MANDATORY SERVICE BULLETIN

No. MSB-E4-007/2 SUPERSEDES DOC. No. MSB-E4-007/1

Replacement of Waste Gate Controller

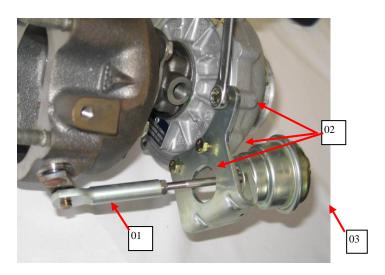
Removal of installed Waste Gate Controller:

- 1. Disconnect Hose at the top of the Waste Gate Controller
- 2. Remove three M6 Bolts [02]
- 3. Remove Circlip [01]
- 4. Disconnect rod from waste gate lever and remove waste gate controller [03]

Install new Waste Gate Controller according to table section 3.1

- 1. Install the three M6 Bolts [02] and torque them with 7 Nm
- 2. Attach external pump to the top of the Waste Gate Controller and apply pressure till the rod starts to move
- 3. Connect rod to waste gate lever
- 4. Adjust Waste Gate Controller according to Engine Maintenance Manual E4.08.04, Chapter 81-00-32.

Note: For fixing of the rod on the waste gate lever use new circlip.
